The proposal seeks planning approval for a 4-lot subdivision at 274 Perth Mill Road, Perth.

PROJECT: 4 LOT SUBDIVISION SCALE: 1:500 SHEET SIZE: A1 DWGs IN SET: rarein.com.au P. 03 6388 9200 ADDRESS: 274 PERTH MILL ROAD, PERTH PROJECT No: 231005 DWG No: C401 REV: 0

Additional Information Required for Planning Application PLN-22-0188 4 Lot Subdivision at 274 Perth Mill Road, Perth

TITLE: CIVIL WORKS PLAN

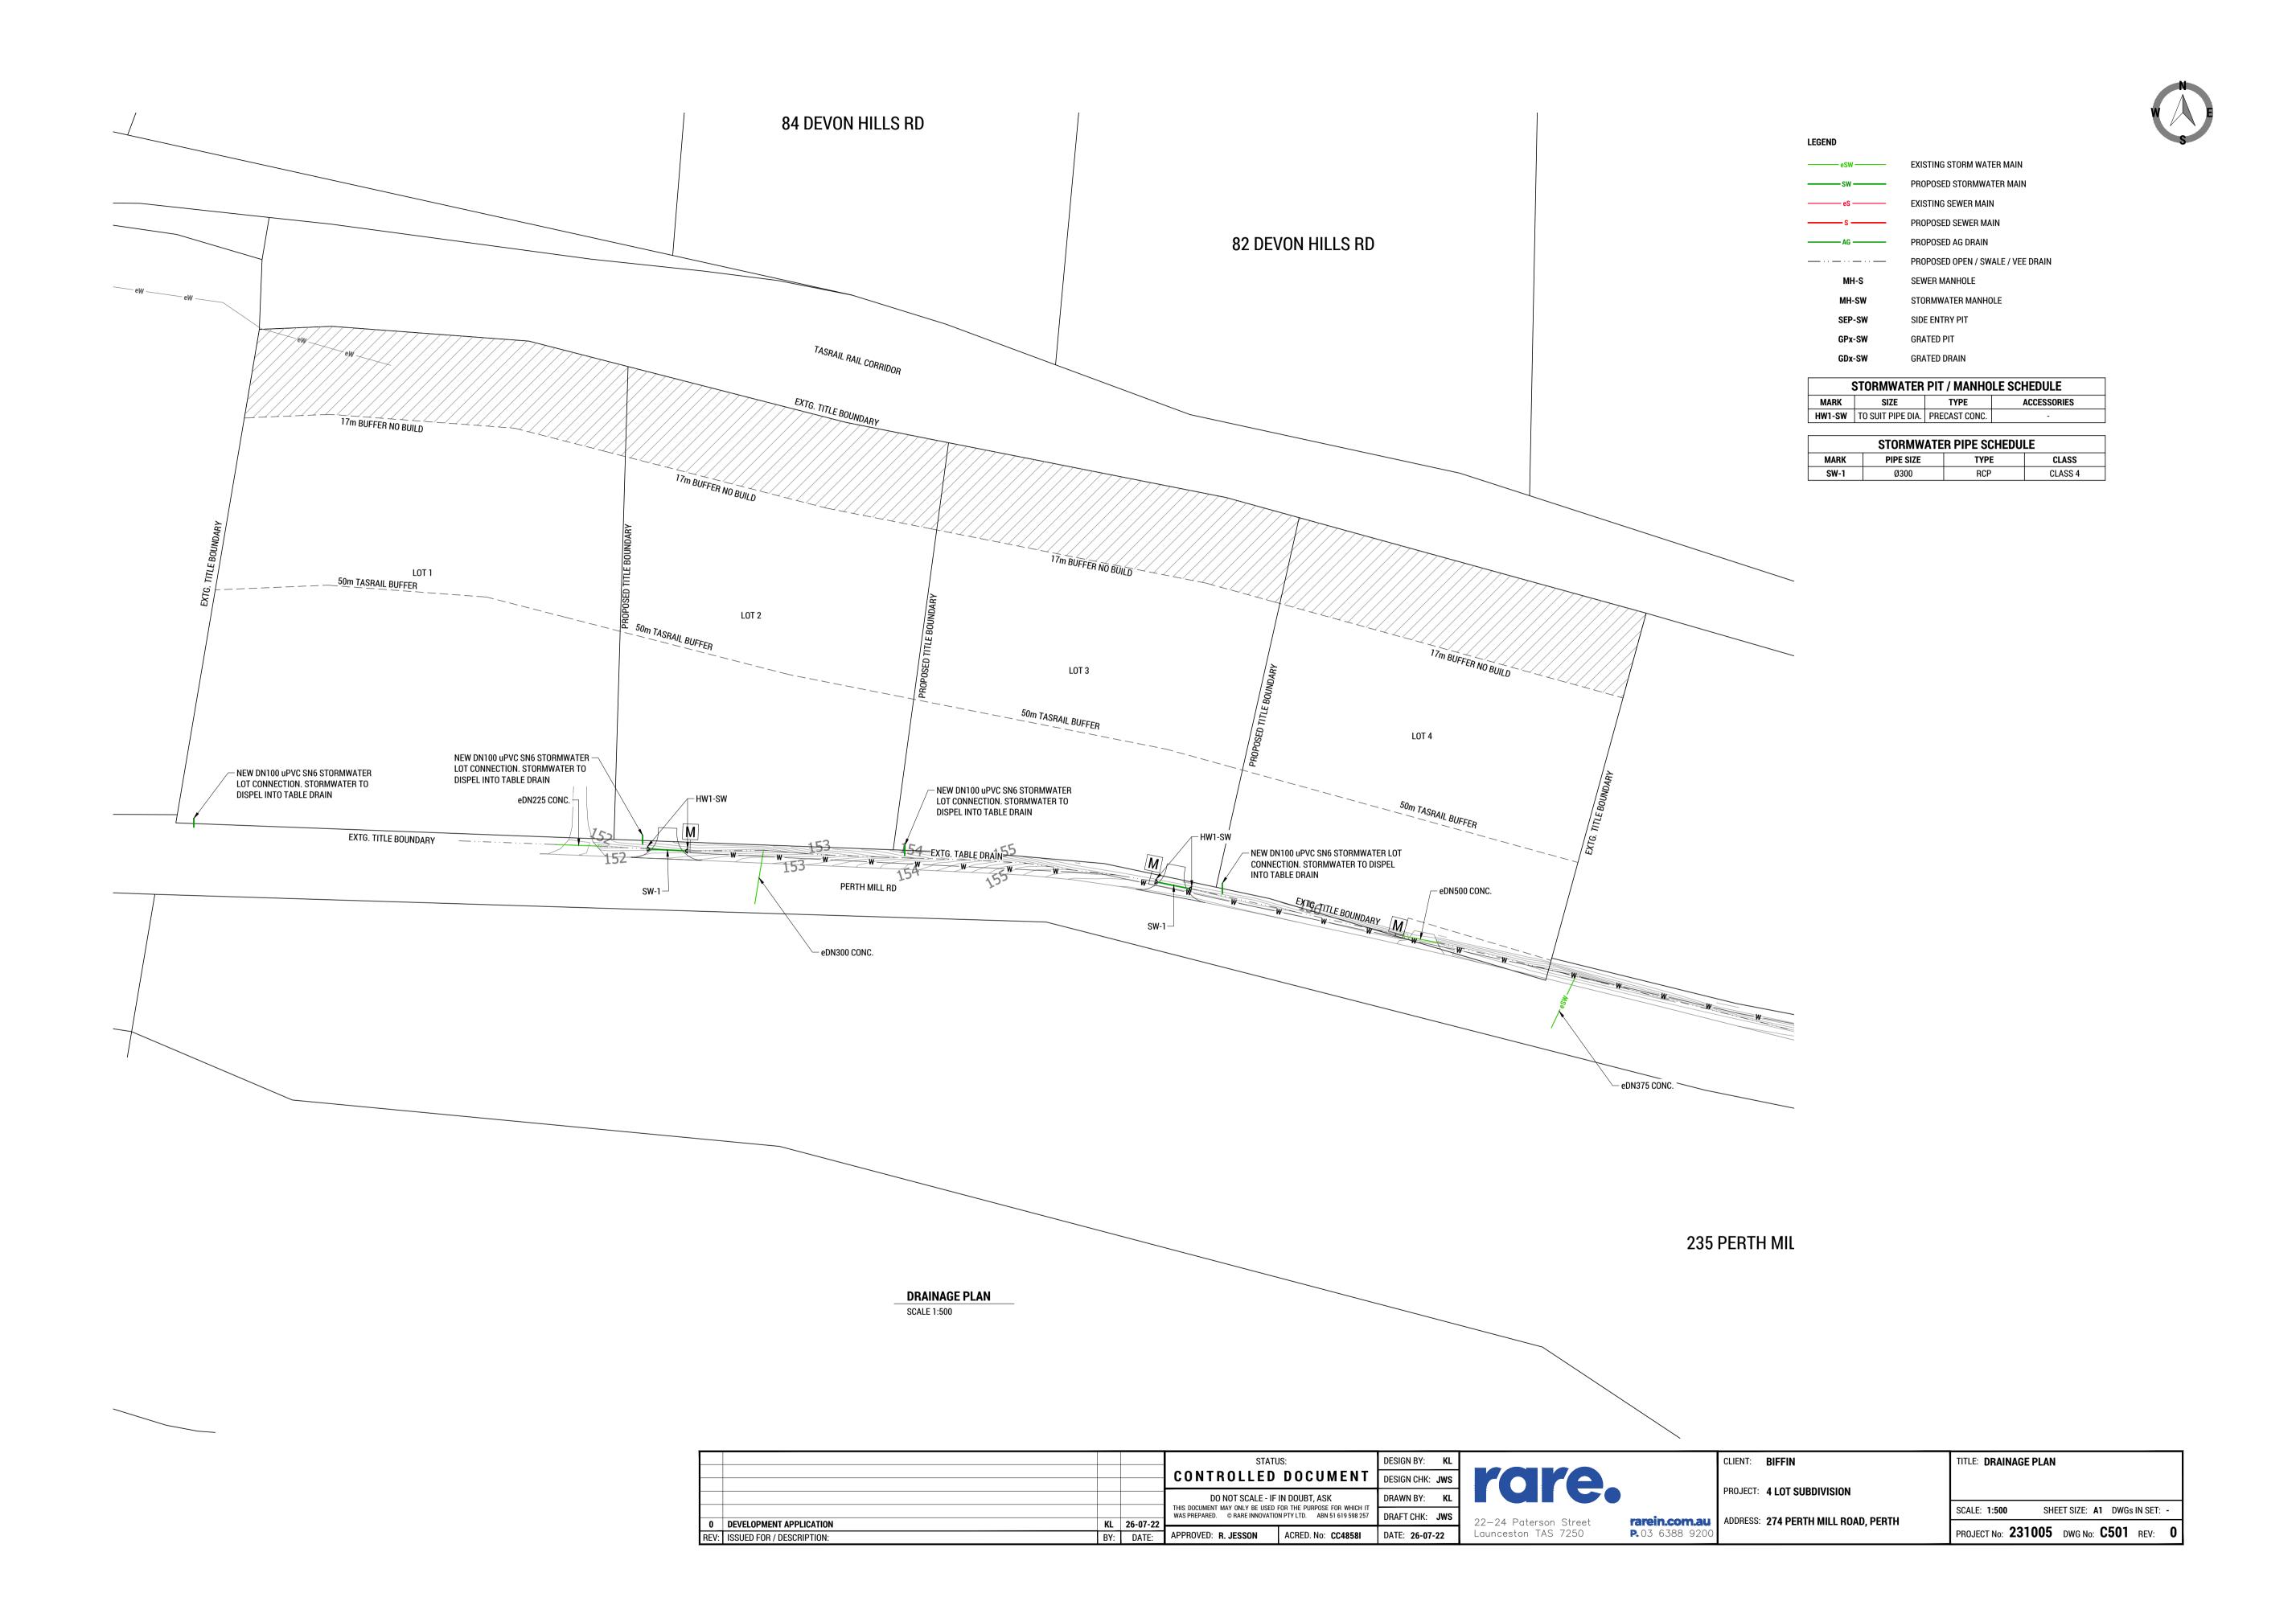
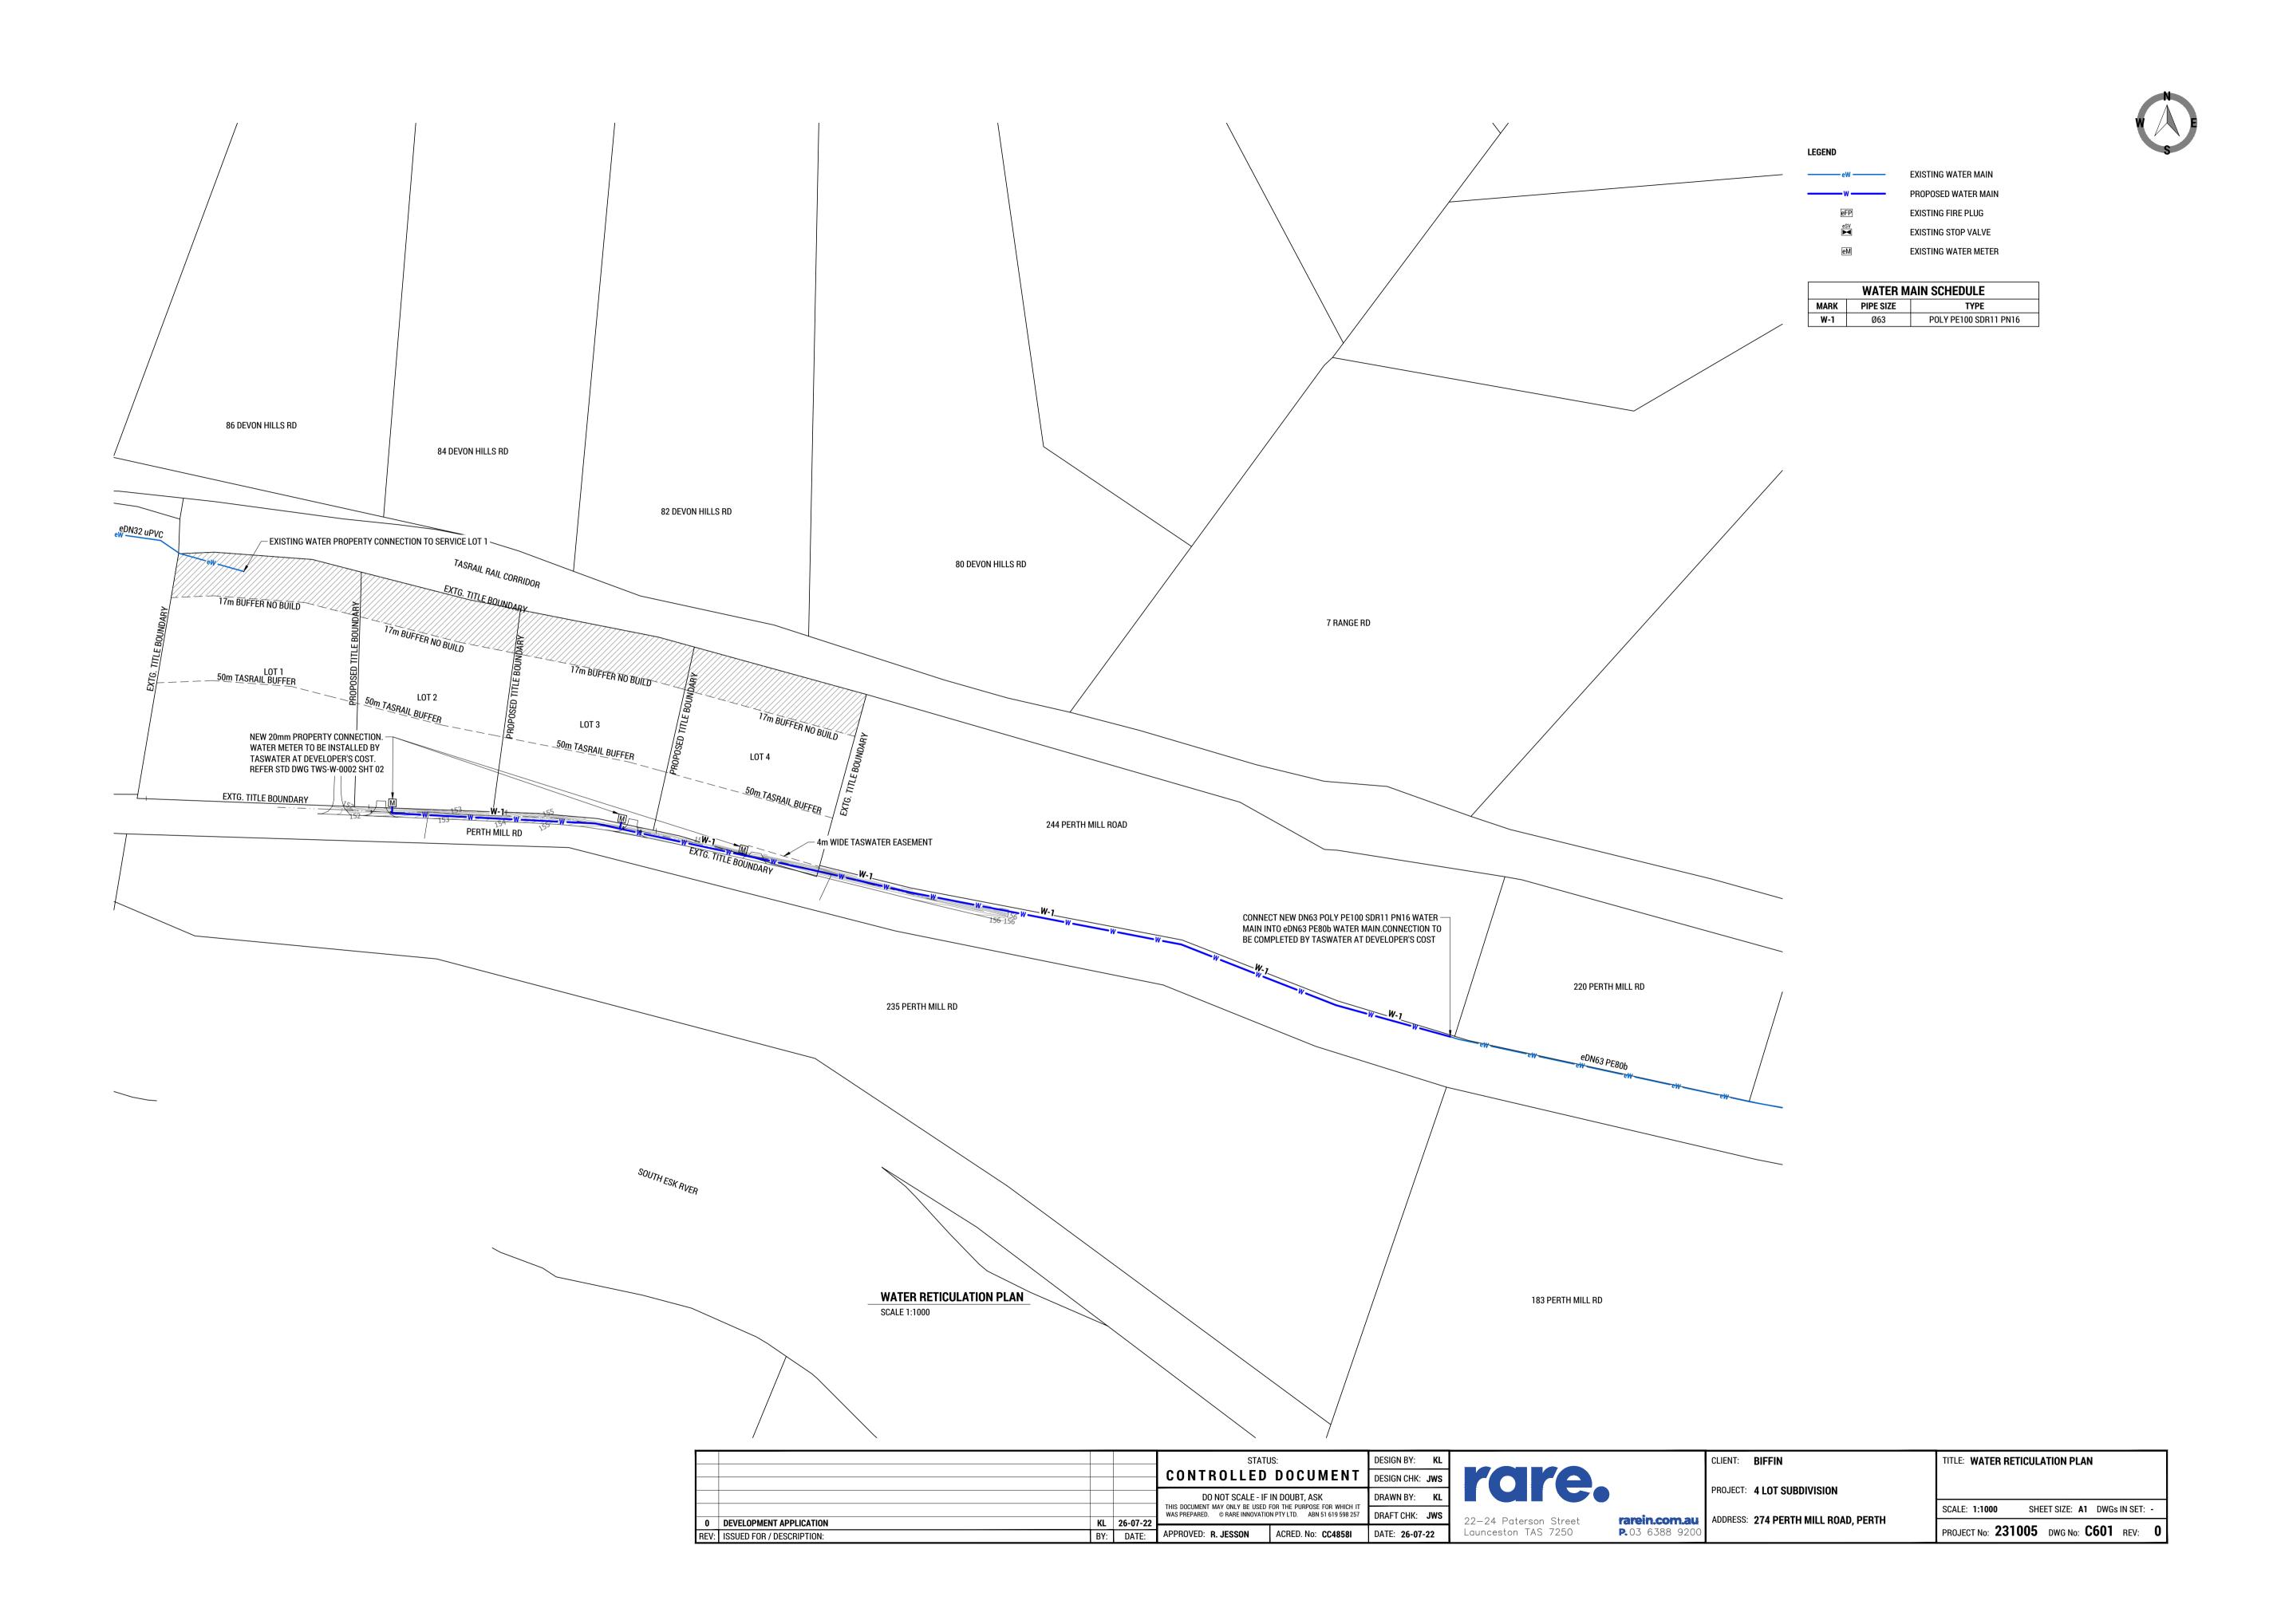
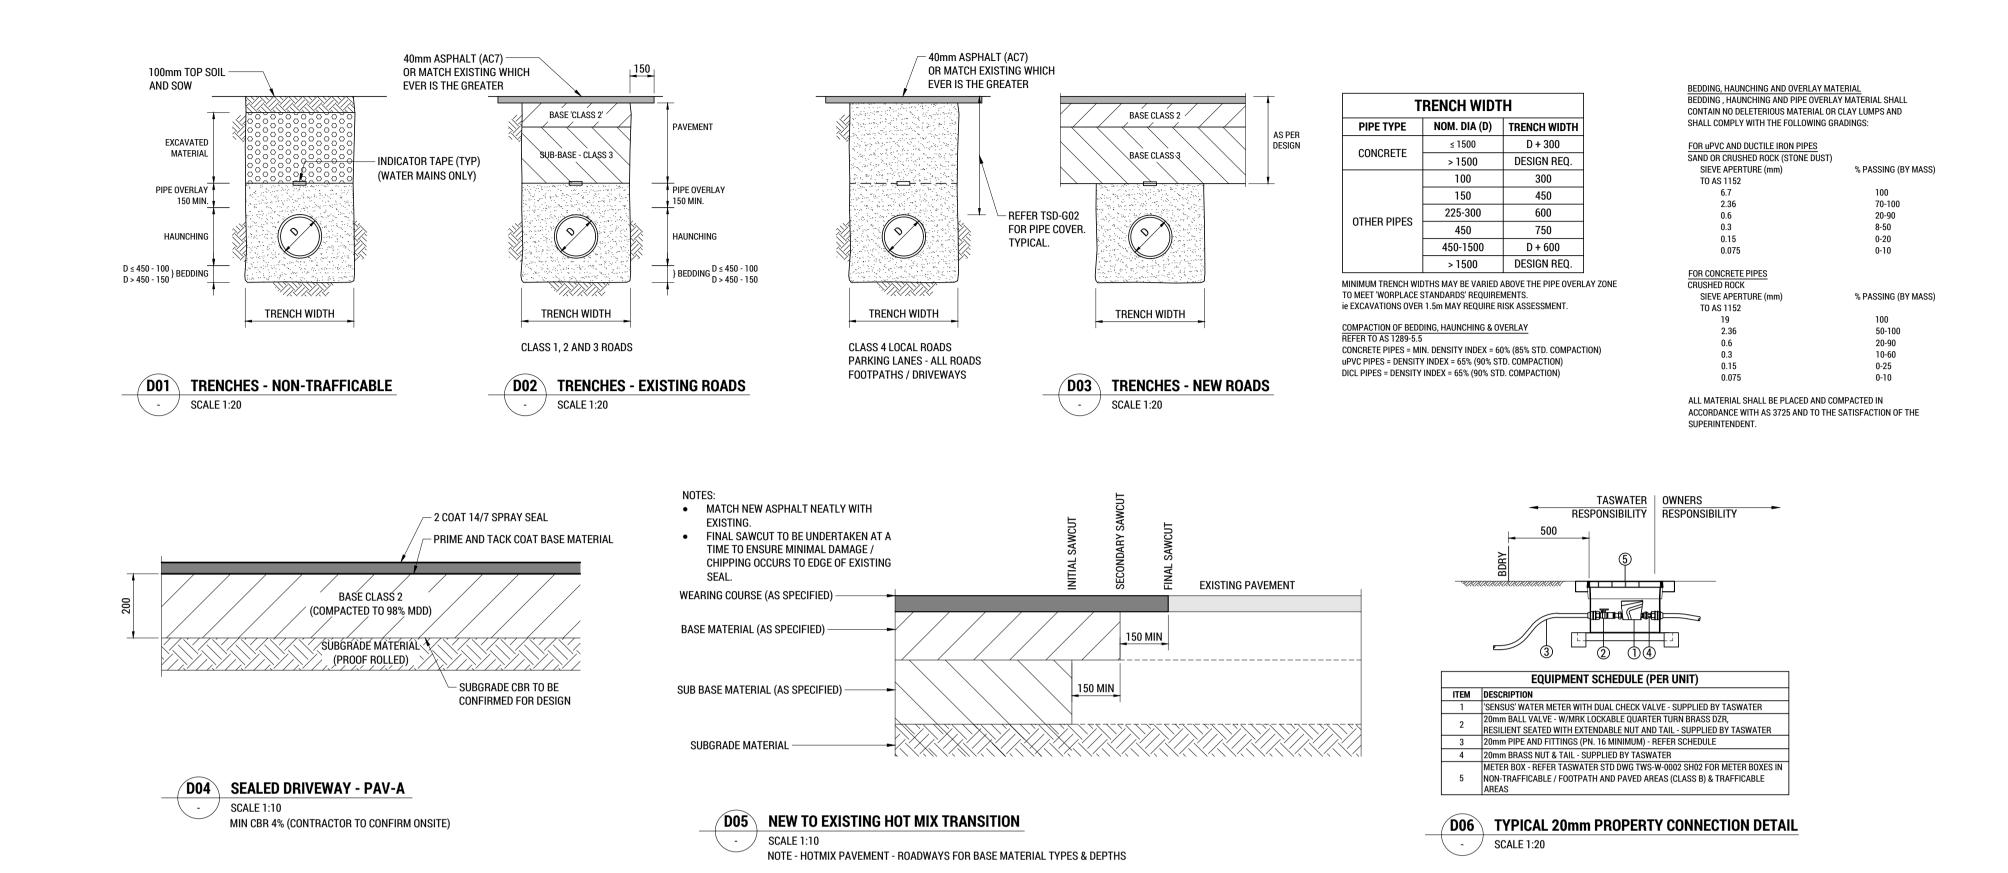
- On the proposed concept plans by Woolcott Surveys shows a section on DN63 water main in front of 244 PERTH MILL RD and it is unclear if this is proposed or existing. Please clarify and provide details. Advice: It is noted that no nearby developments have reached Practical Completion and therefore TasWater has not accepted ownership of these assets. Neighbouring developments will need to be completed, finalised and accepted before any connections can be made.

- 2. The existing DN63 main on PERTH MILL RD has reached its design capacity and the following will need to be required;
 - a. Plans that show an upgrade of the existing DN63 to DN100 approx 380M from the existing DN100 main further down Perth Mill Rd past the last existing connection.
 This is to ensure adequate supply to this development and no detriment to any existing connections. Or;

- b. Provide a compliant water model TasWaters satisfaction demonstrating adequate minimum supply to all lots on the existing (including pre-approved yet to be installed) & proposed connection. DN63 line. (see modelling advice below).
